Match ellis project name:
CLE/WAR SR 48 6.65 Sidewalk

CLE/WAR SR48 6.65 & BUTTERWORTH SIDEWALK

STAGE 1 SUBMITTAL - AUGUST 29, 2025

TITLE SHEET

PLAN AND PROFILE - STATE ROUTE 48
STA. 131+00 TO STA. 134+00

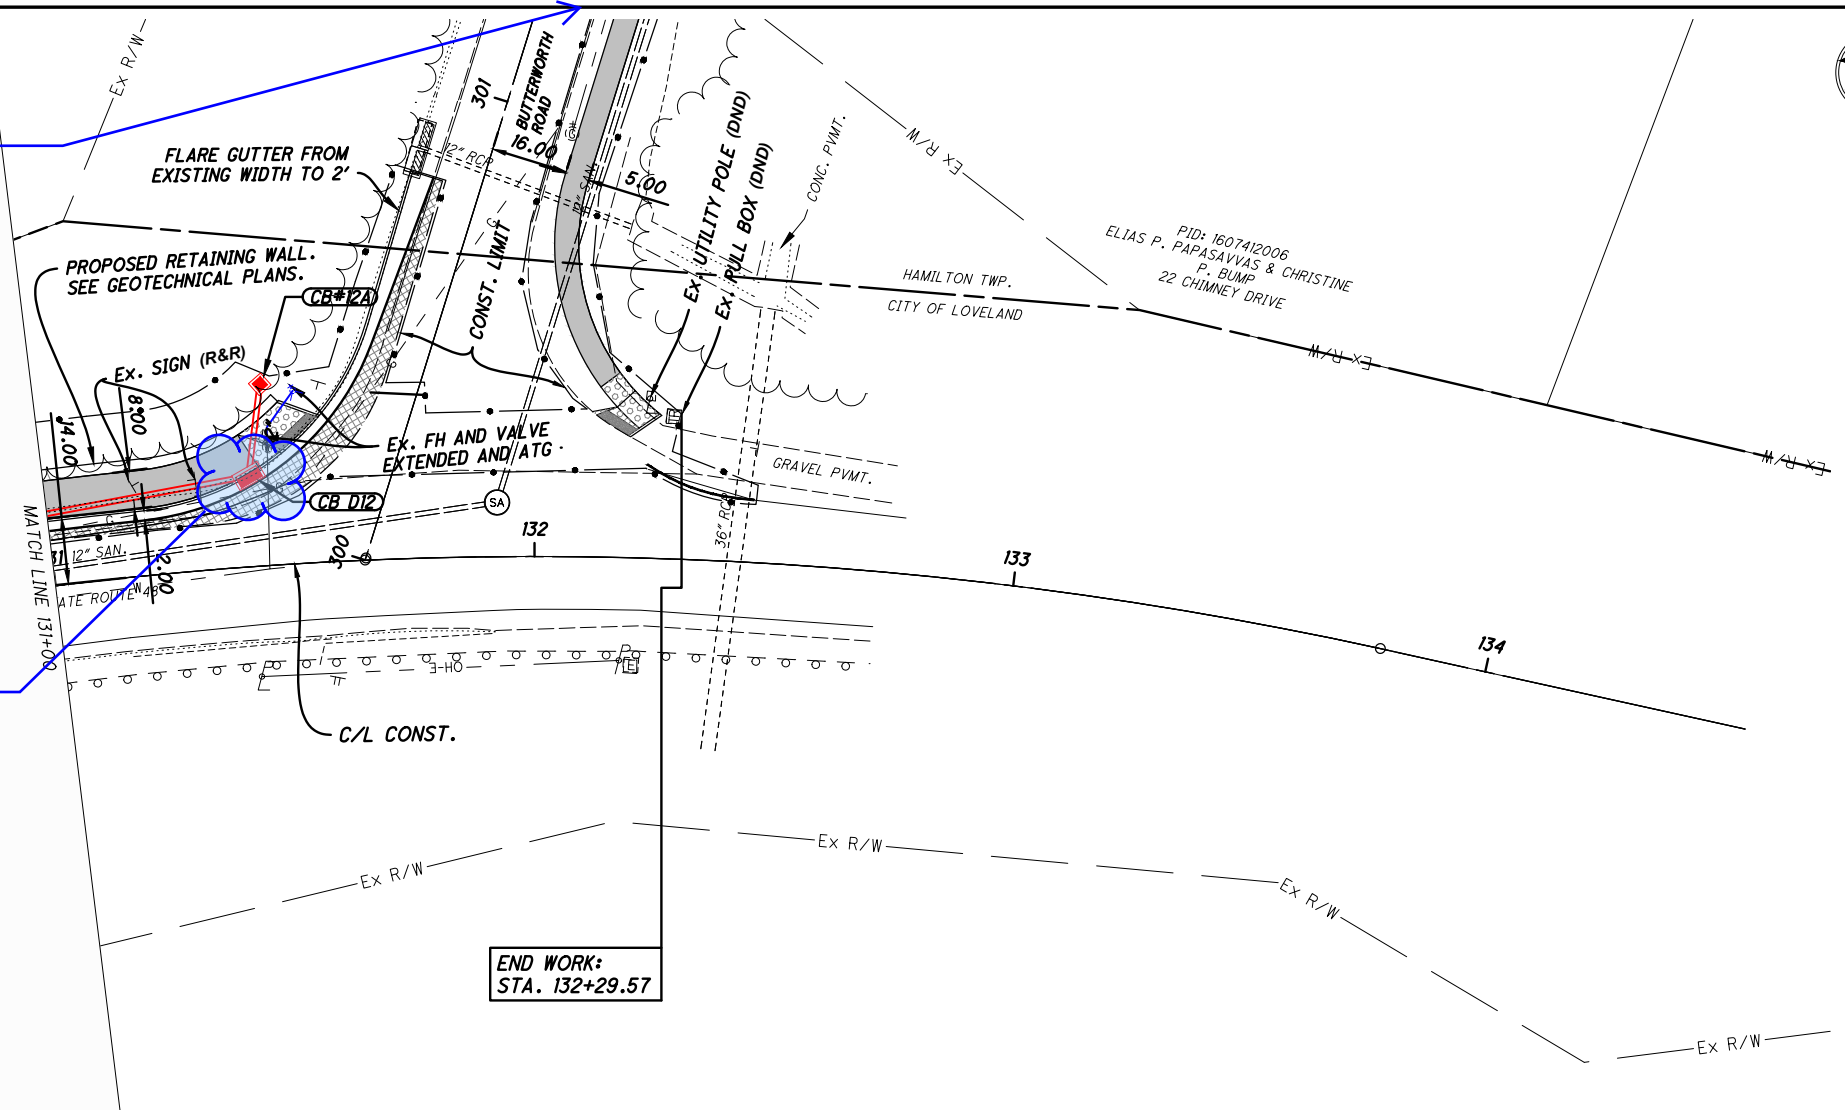
show a match line stationing and sheet number.

Will gas main be relocated?
Confirm sufficient r/w acquired

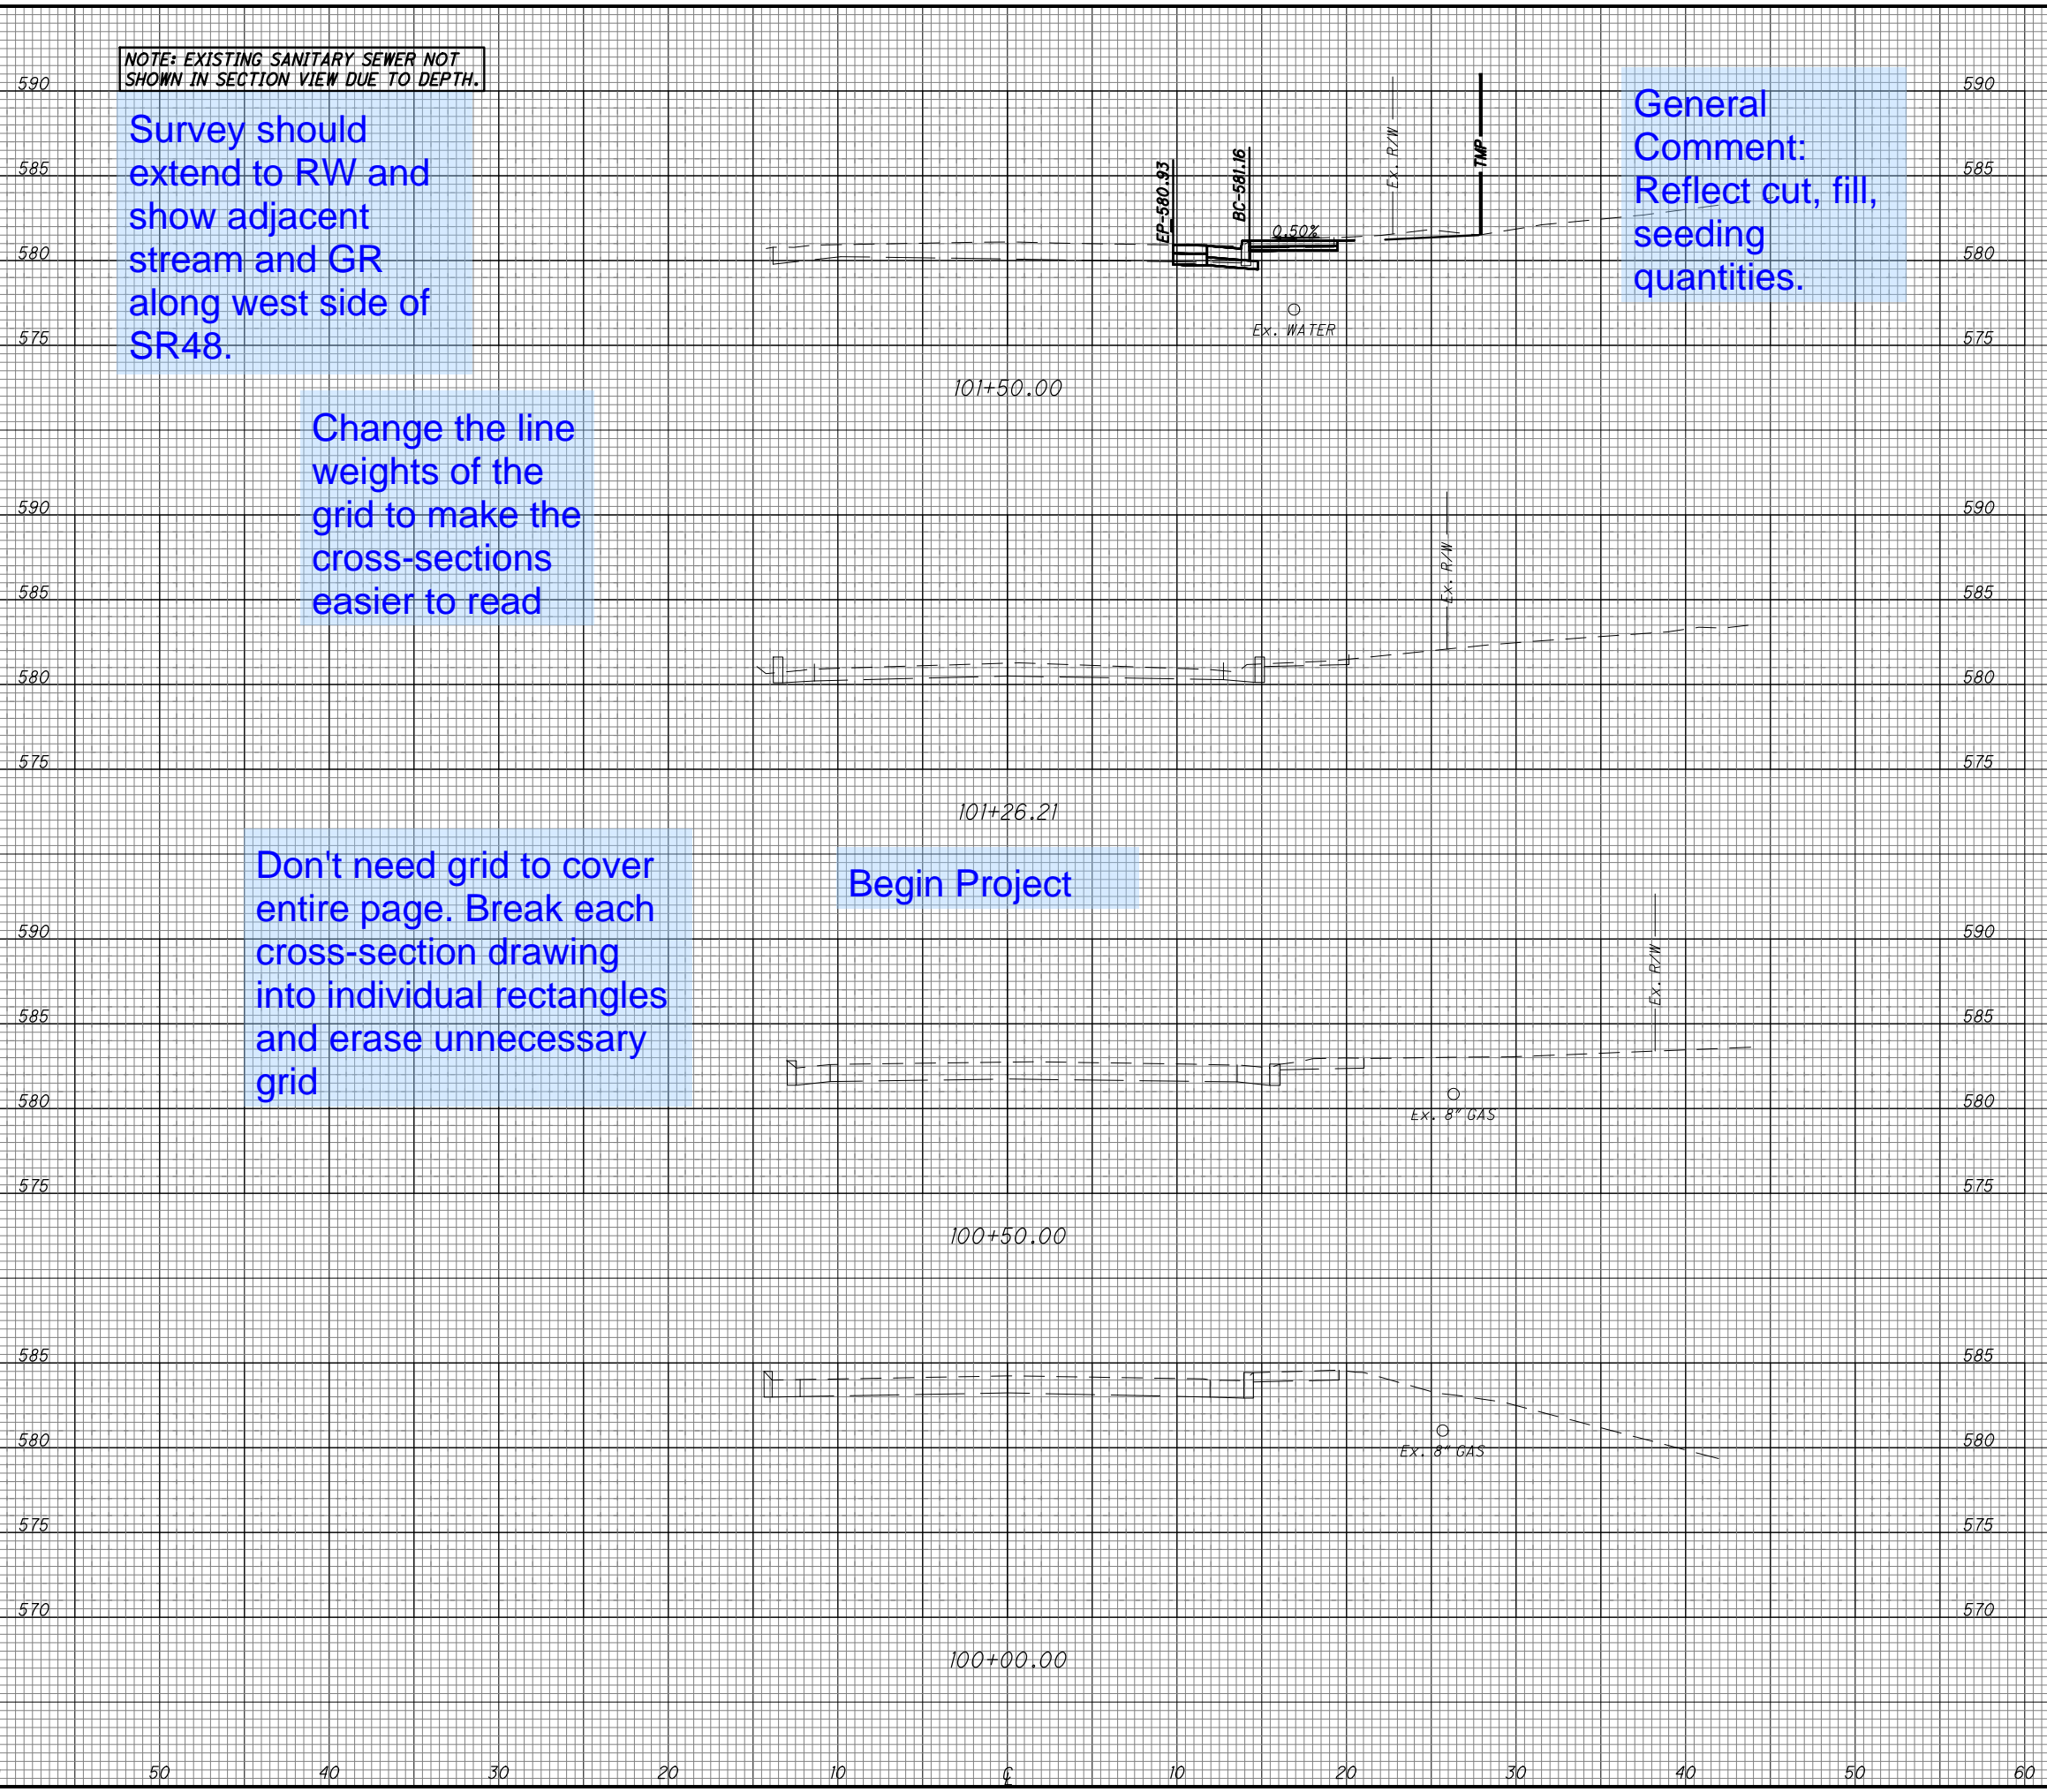
Survey should extend to RW and show adjacent stream and GR along west side of SR48.

Change the line weights of the grid to make the cross-sections easier to read

Don't need grid to cover entire page. Break each cross-section drawing into individual rectangles and erase unnecessary grid

General Comment: Reflect cut, fill, seeding quantities.

PLAN AND PROFILE - OVERLOOK DRIVE
STA. 200+00 TO STA. 204+00

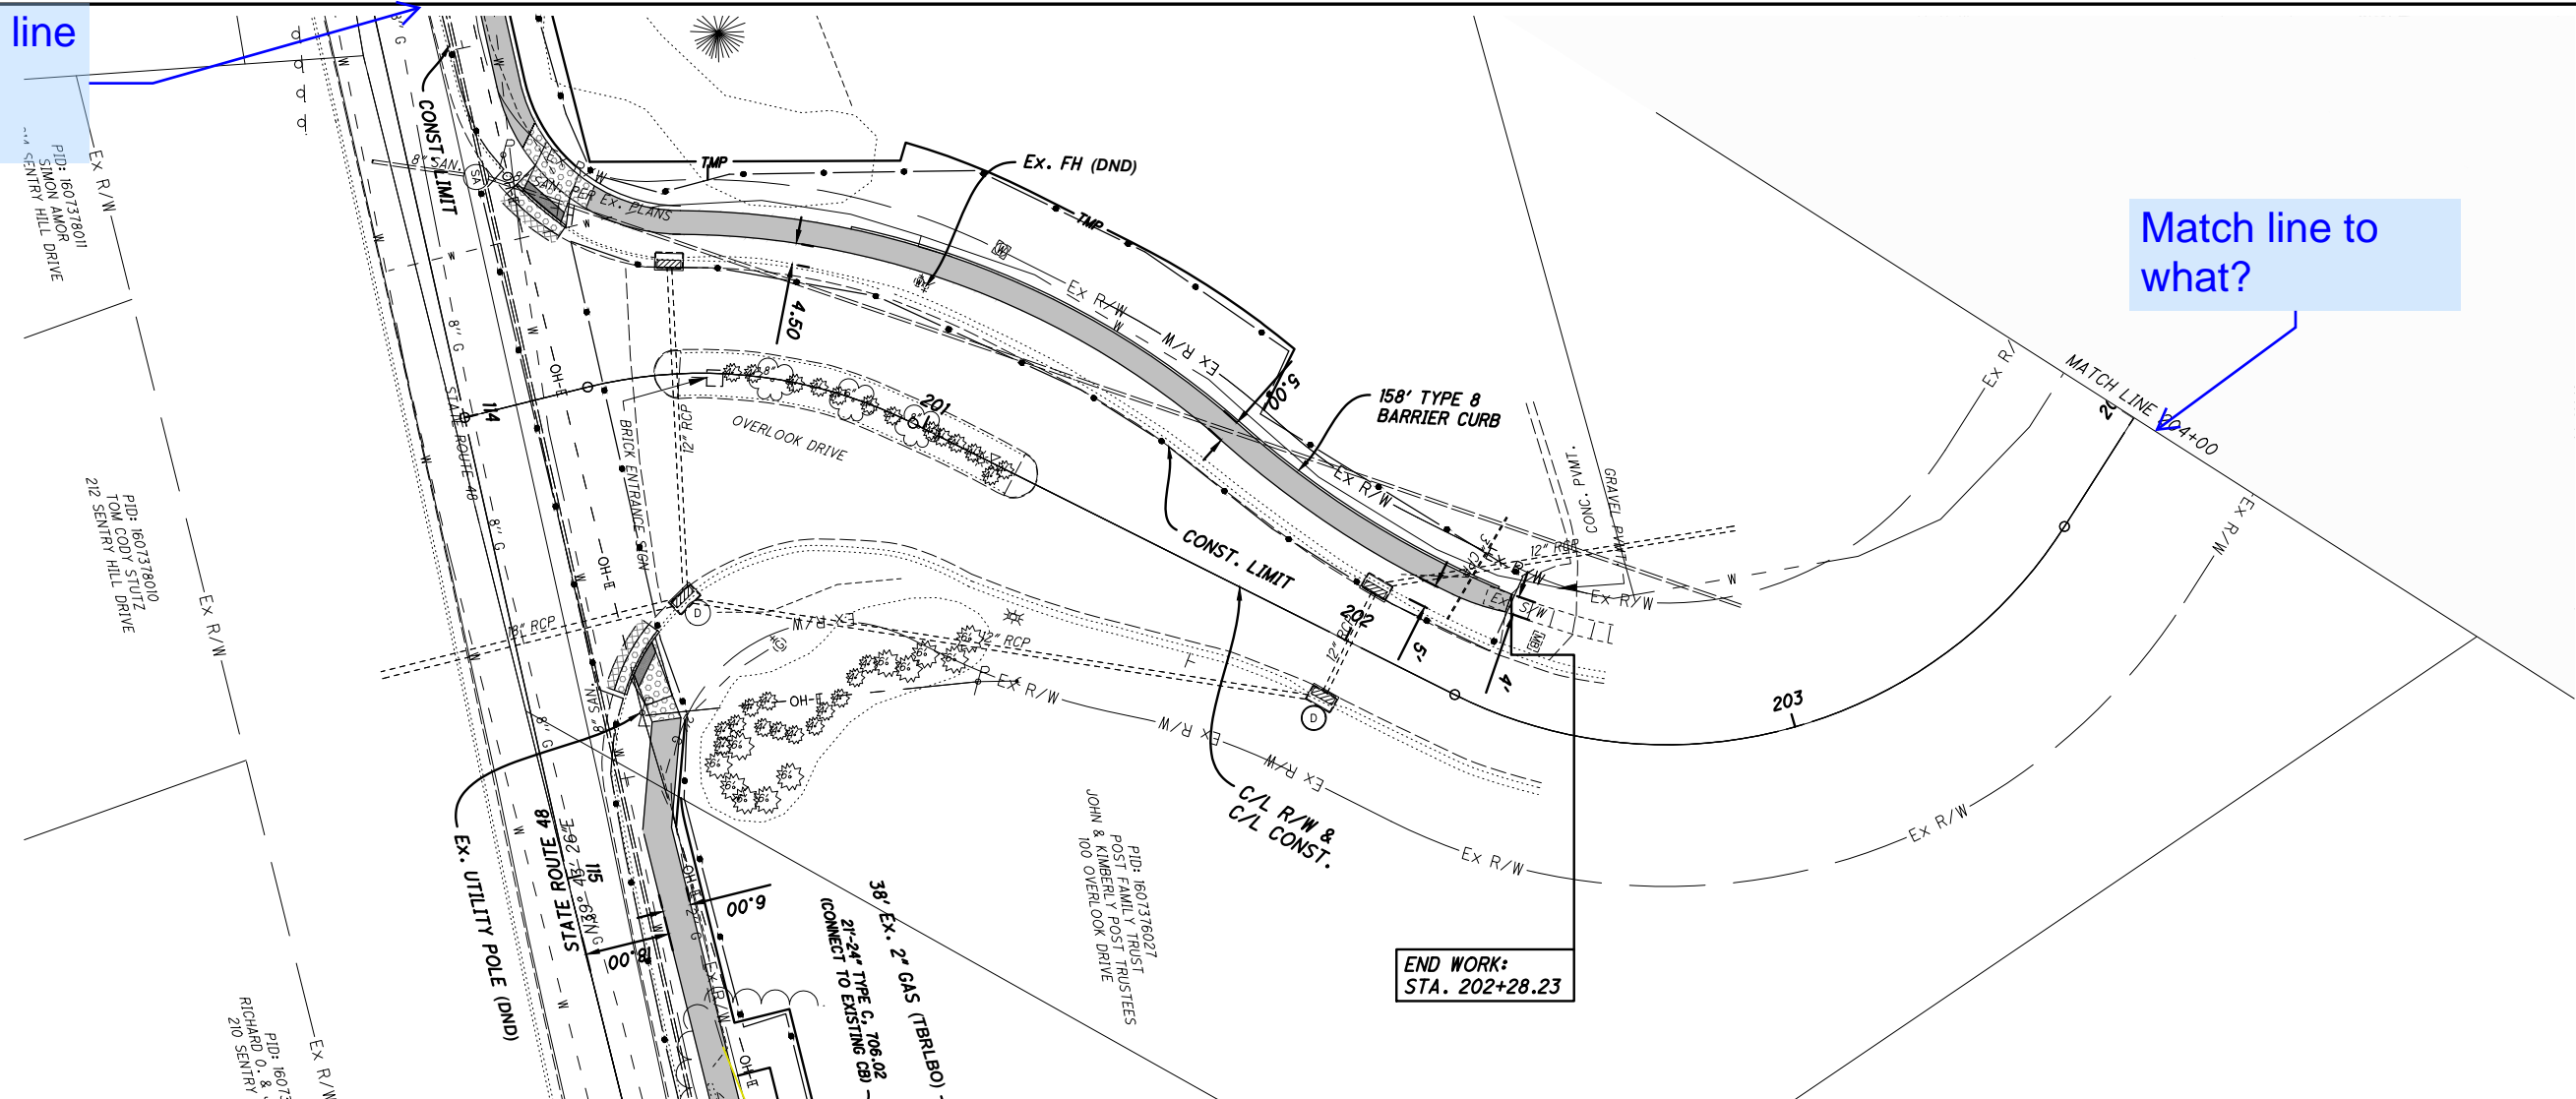
Show match line and sheet number.
